DESIGNED: MAB DRAWN: HIG CHECKED: MAB DATE: 11/26/18	REVISION
RESPEC 3520 AUSTIN BLUFFS PARKWAY SUITE 102 COLORADO SPRINGS, CO 80918 PHONE (719) 266-5212	
<p>Know what's below. Call before you dig.</p> <p>PROJ NO. 03524          DWG NM. 03524-Dev-Fil2</p>	Guman & Associates, LLC 731 N Weber St, Suite 10 COLORADO SPRINGS, CO. 80903
ROADWAY PLAN OVERALL	GLENEAGLE SUBDIVISION, FIL #2
DRAWING NUMBER: <b>C</b>	SHEET 1

GLENEAGLE SUBDIVISION, FIL #2

STONE EAGLE PL PLAN AND PROFILE

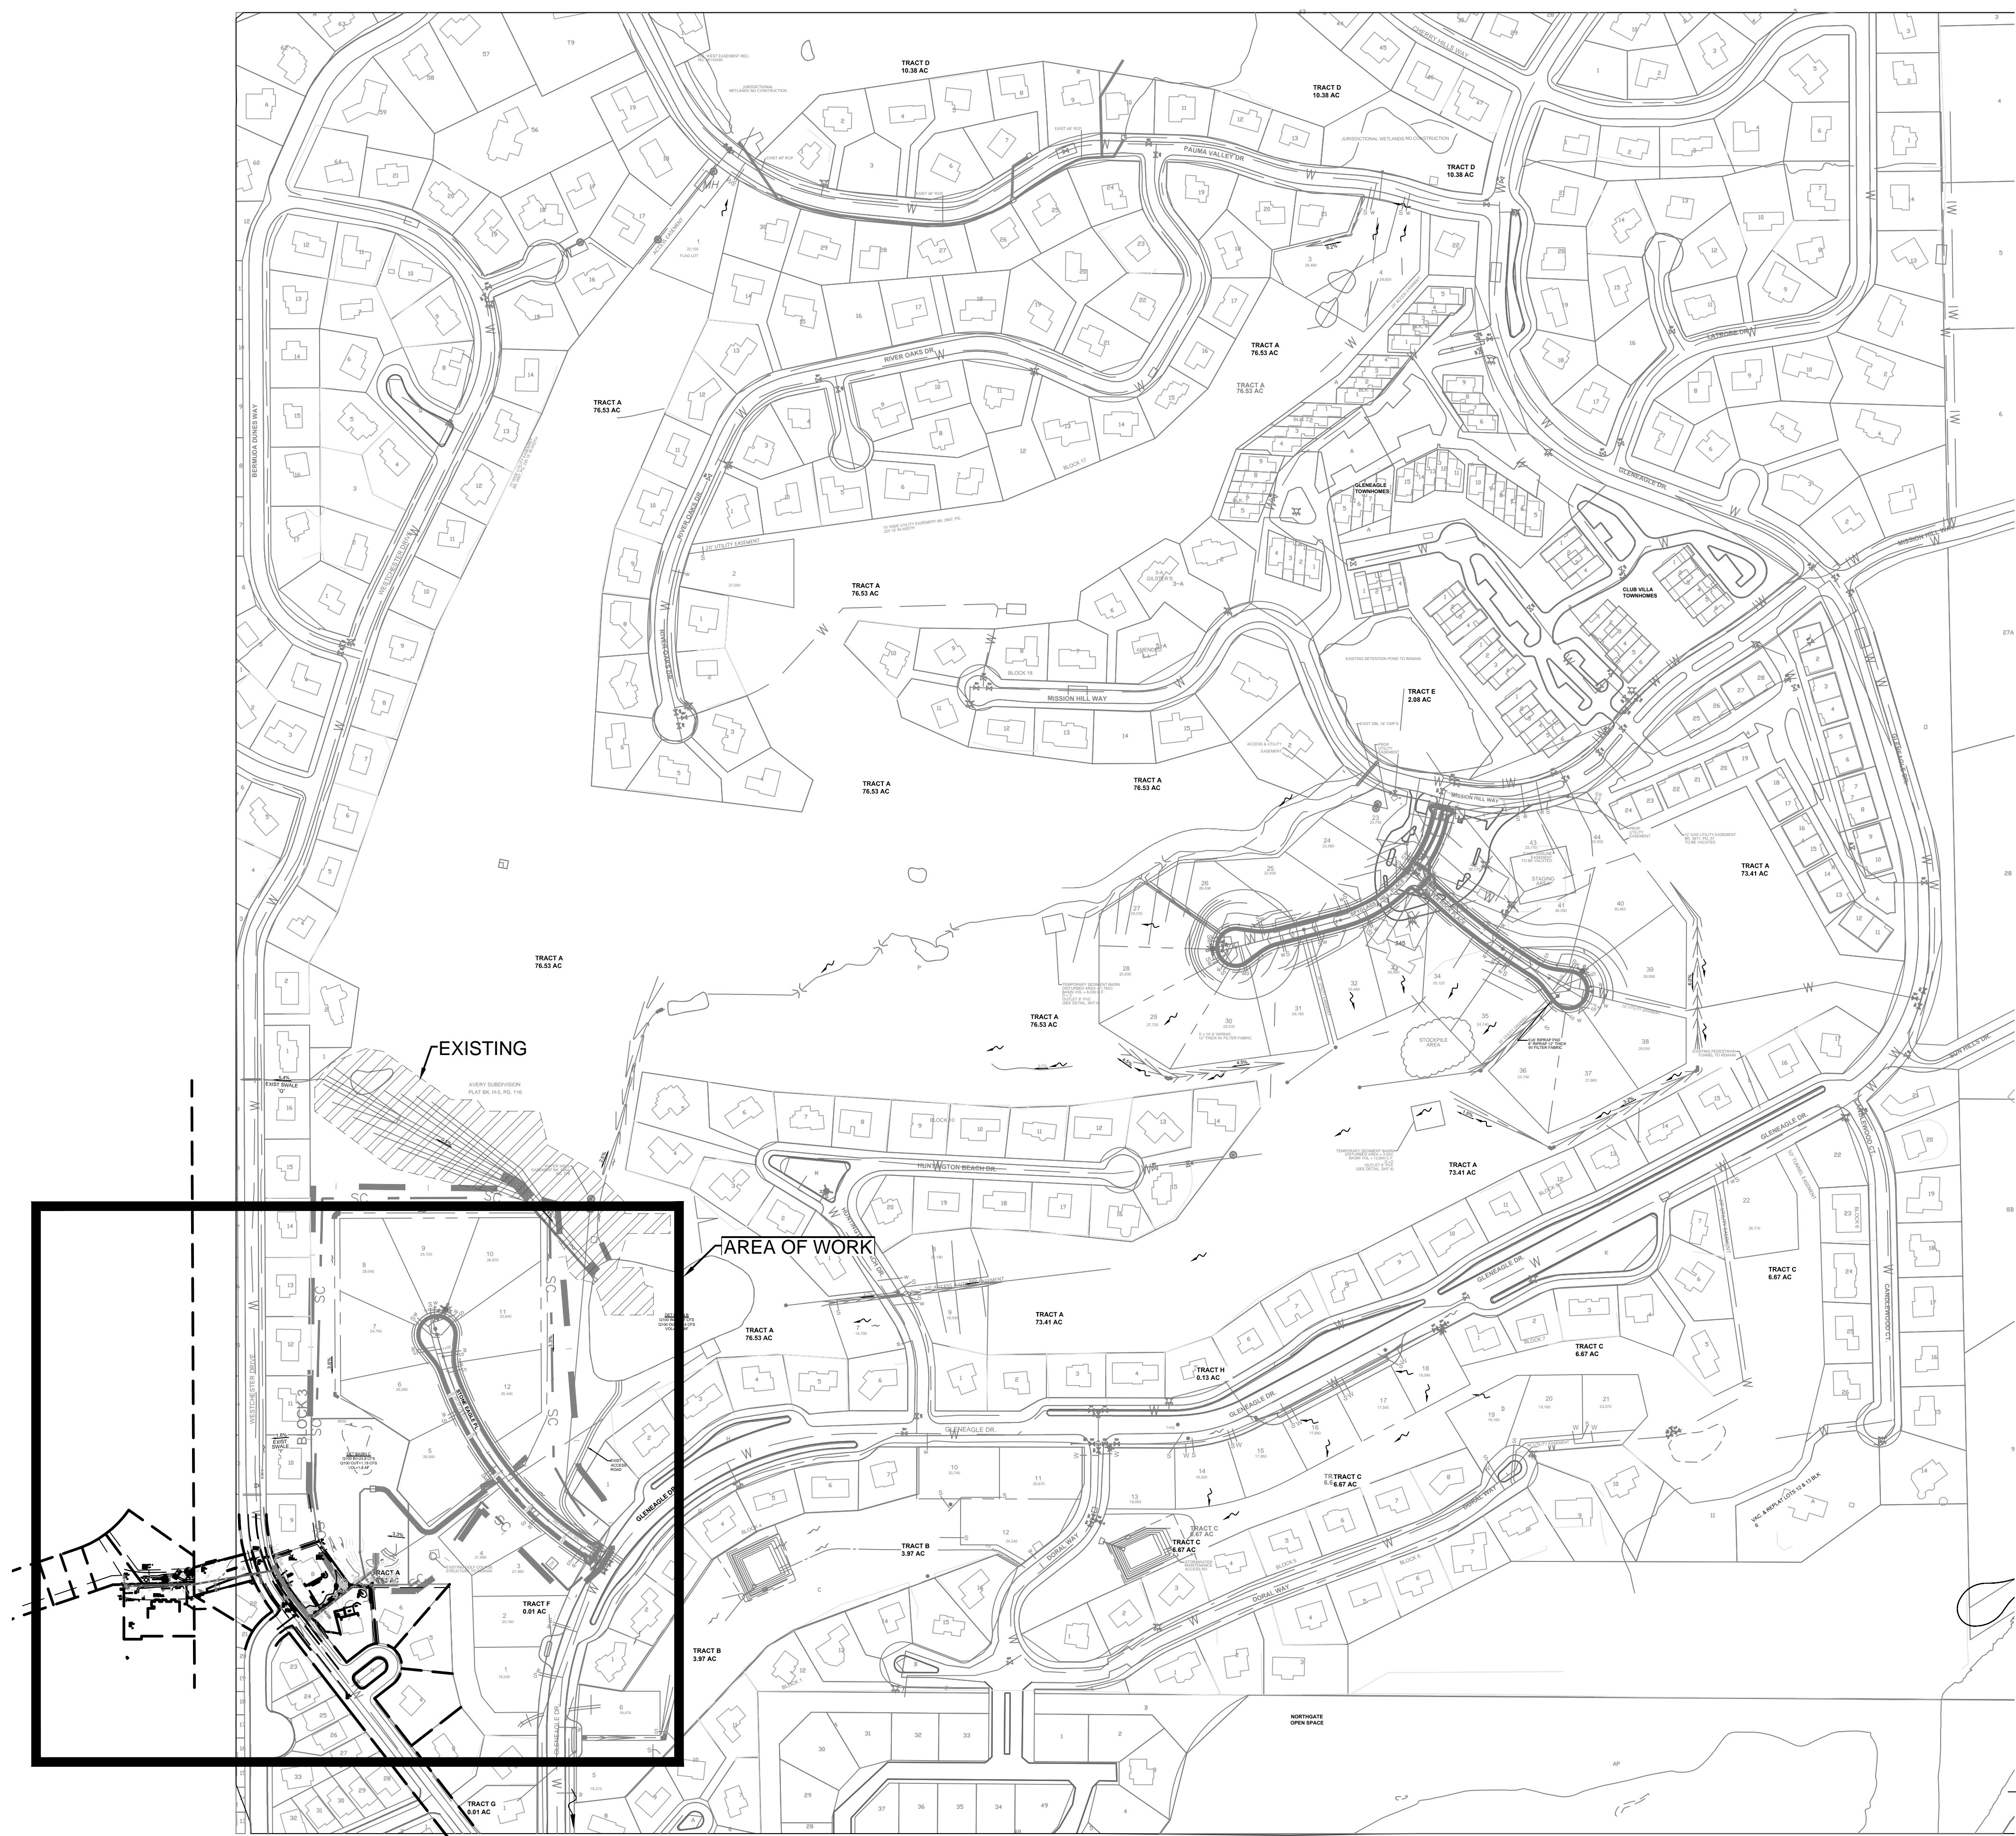
Include the (revised) public storm sewer plan and profile in this set.

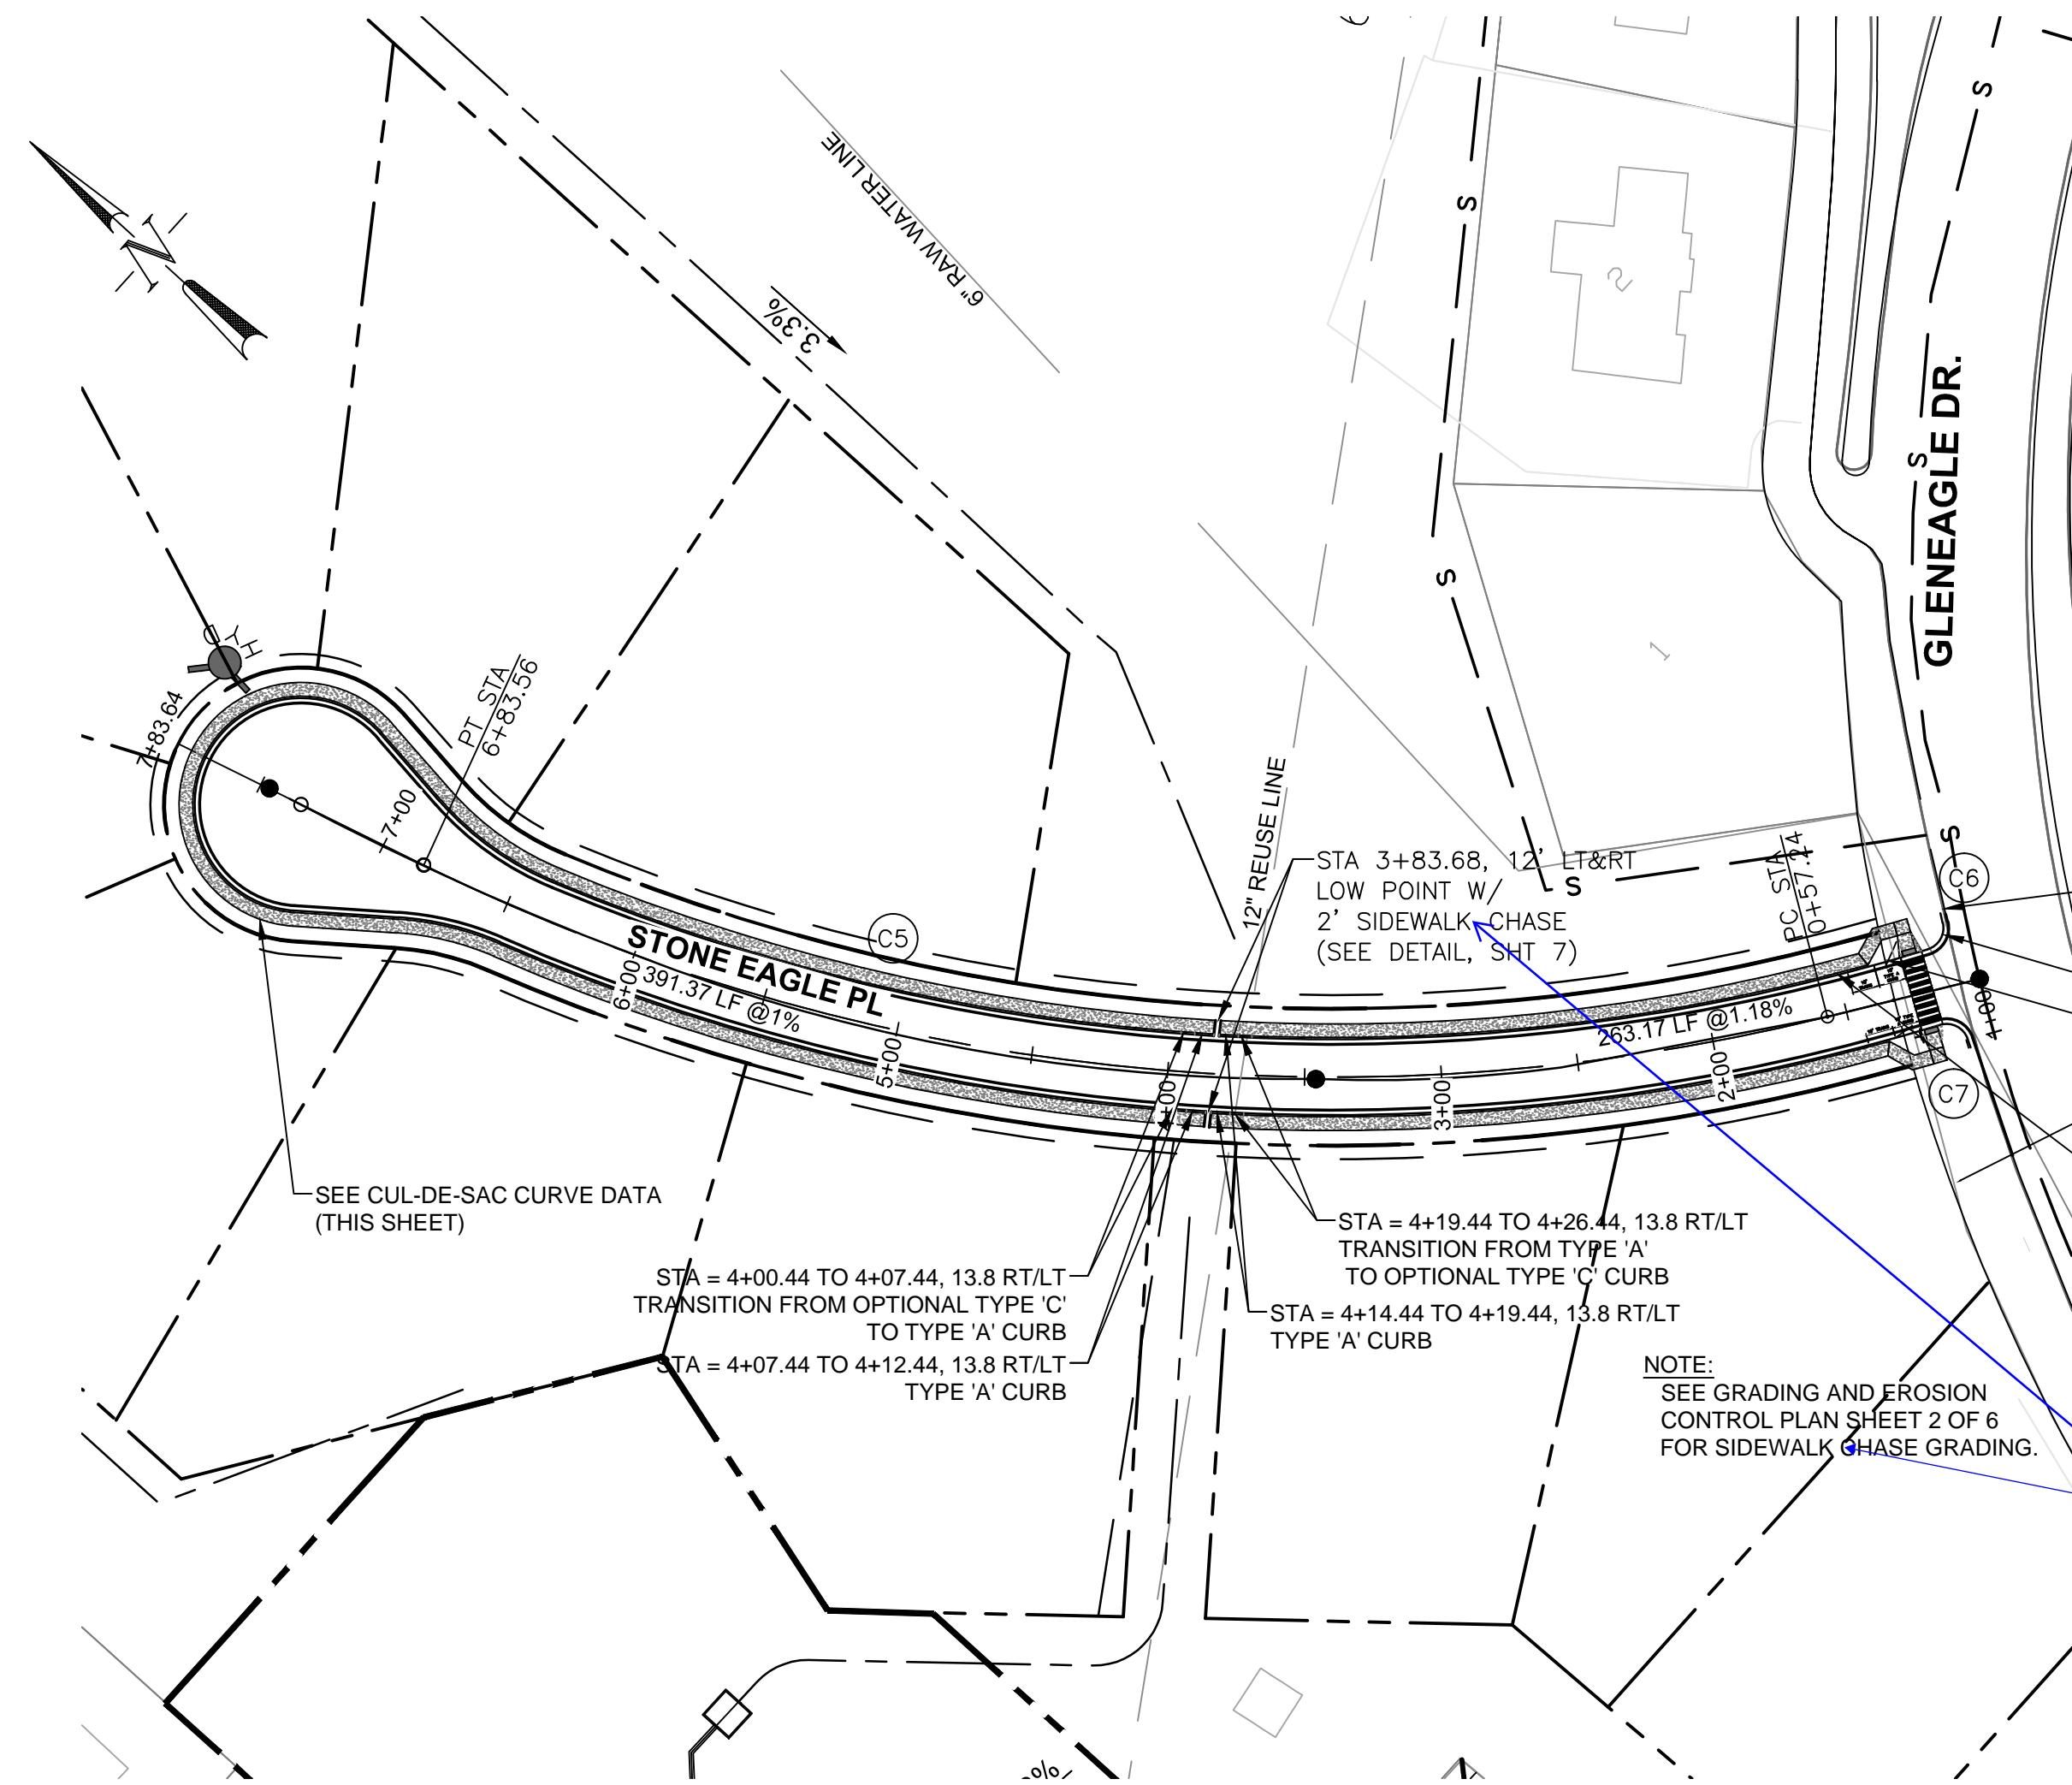
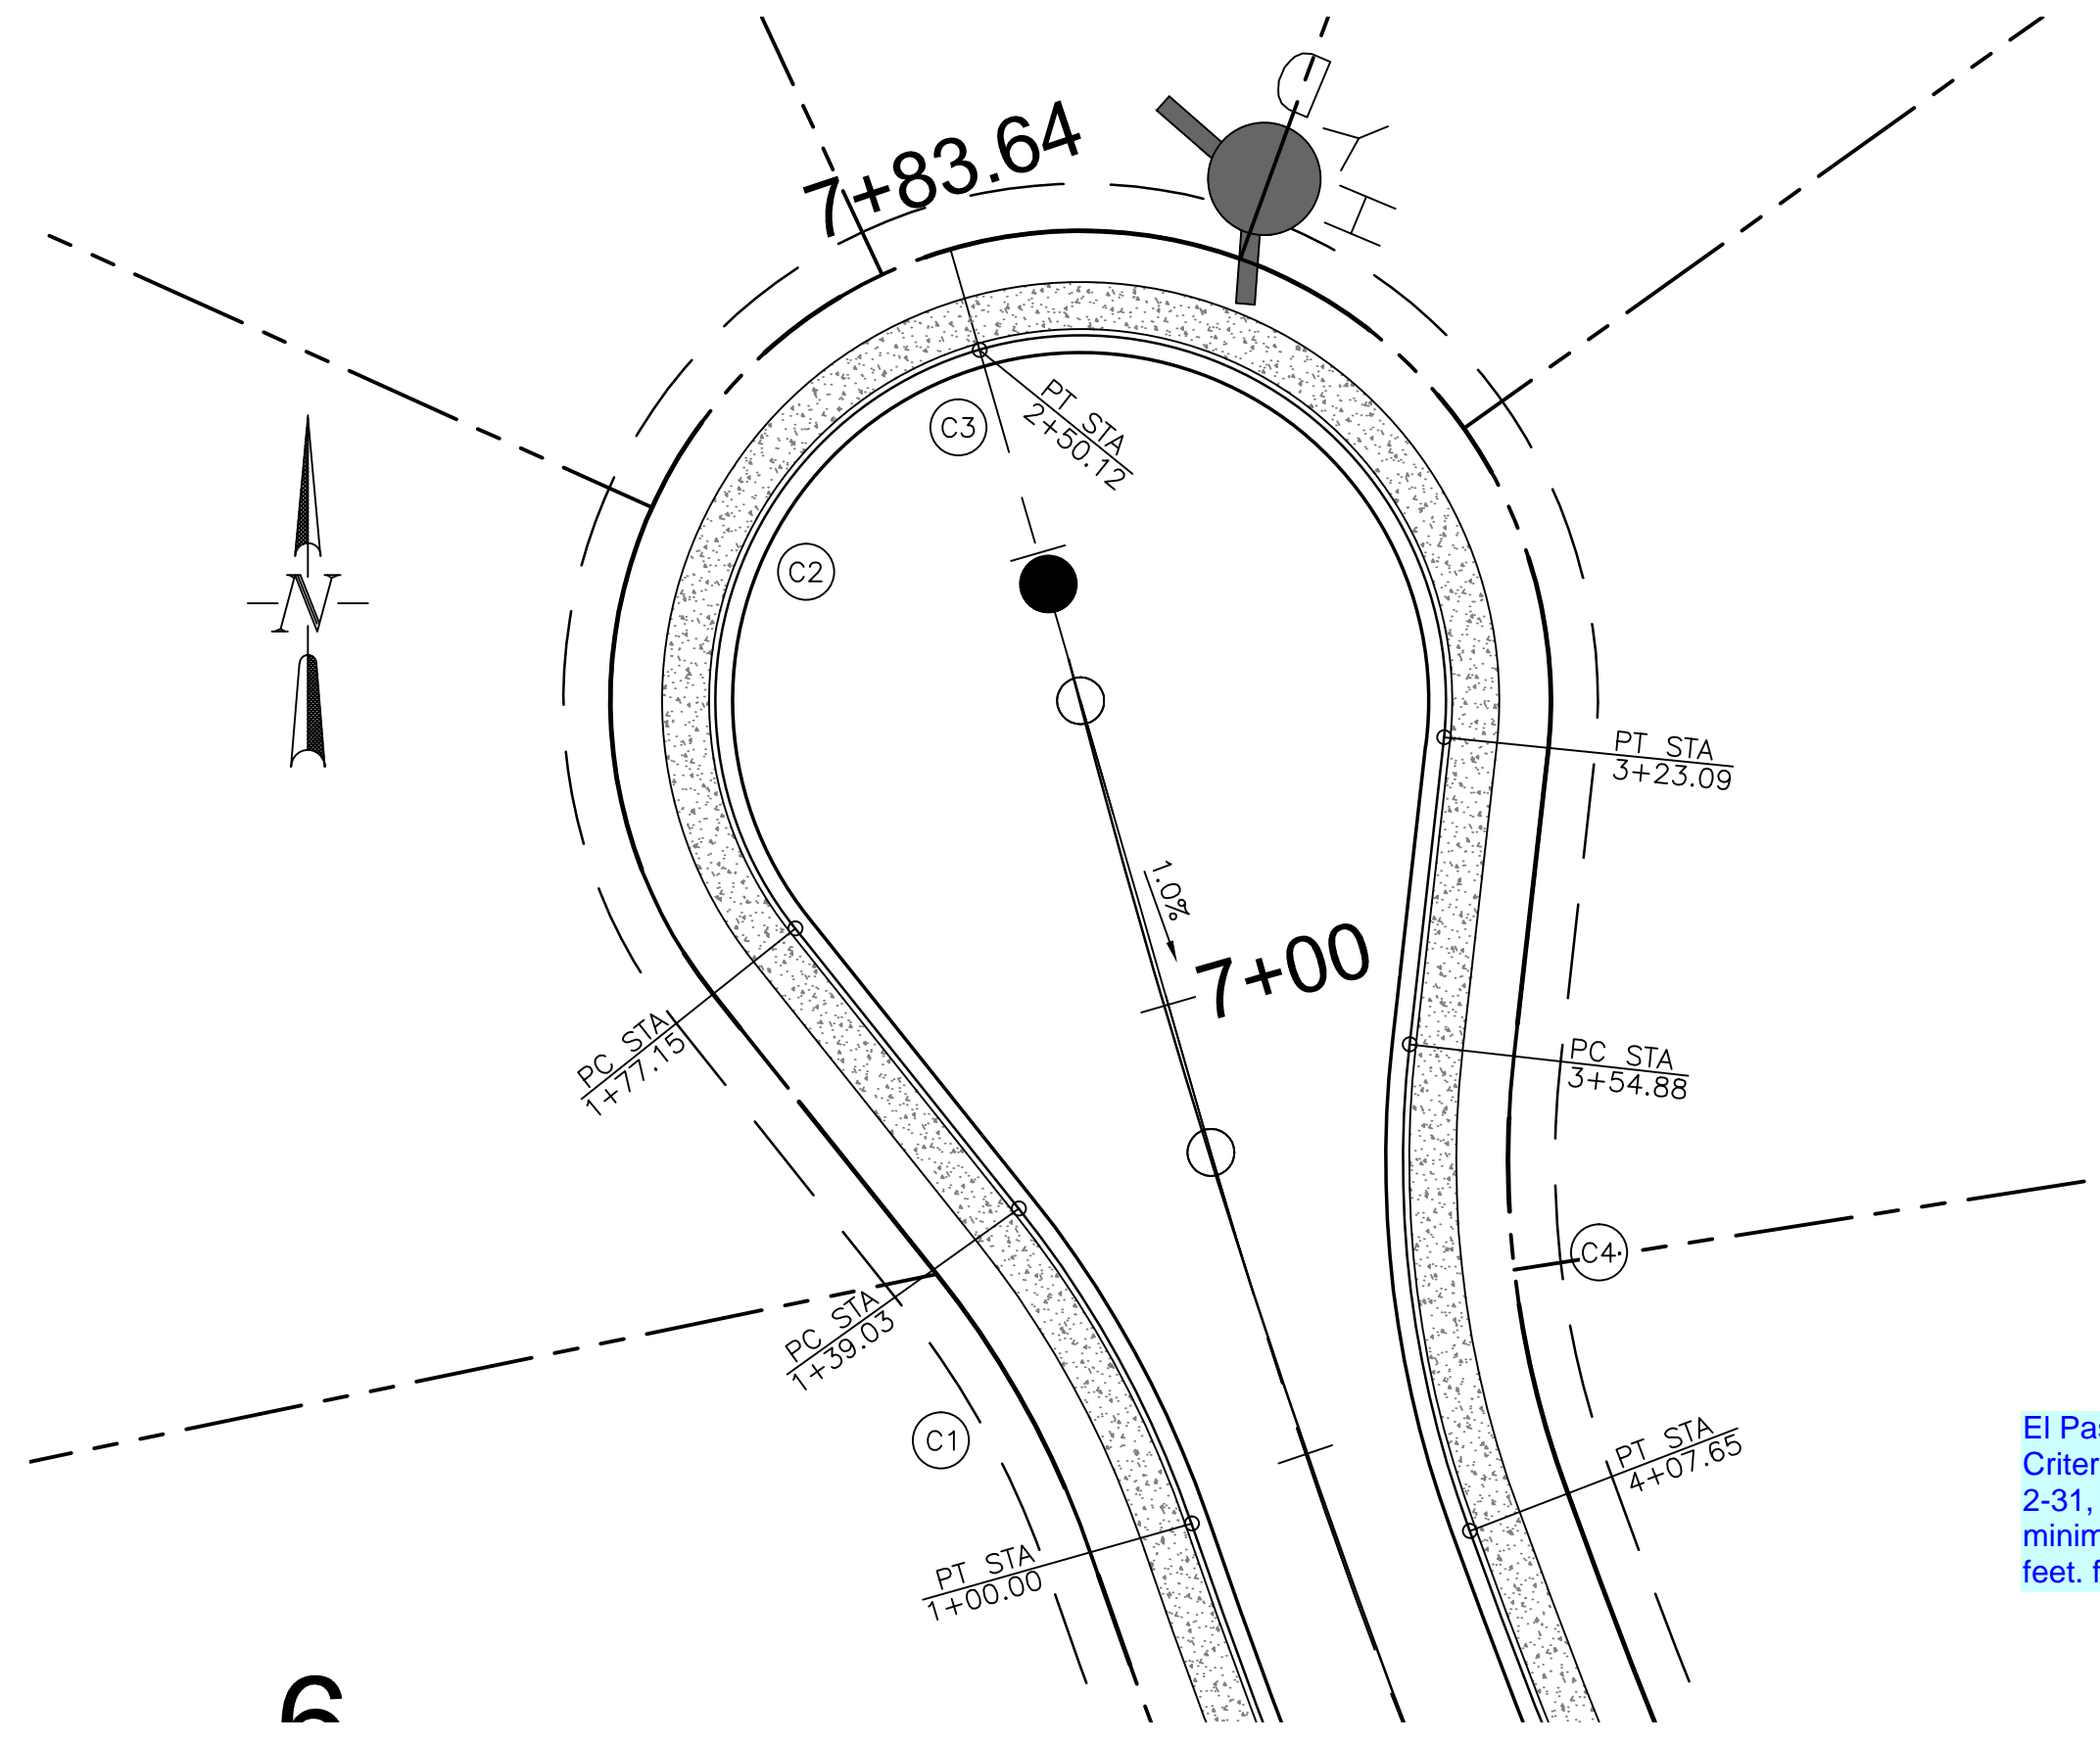
Change to El Paso County standard curb inlets.

El Paso County Criteria ECM Figure 2-31, requires a minimum radius of 45 feet for a cul-de-sac.

Revise, two sets of dimensions occupy the same space. Also a portion of the text has been cut off.

Revise, two sets of dimensions occupy the same space. Also a portion of the text has been cut off.

Change to El Paso County standard curb inlets.

El Paso County Criteria ECM Figure 2-31, requires a minimum radius of 45 feet. for a cul-de-sac.
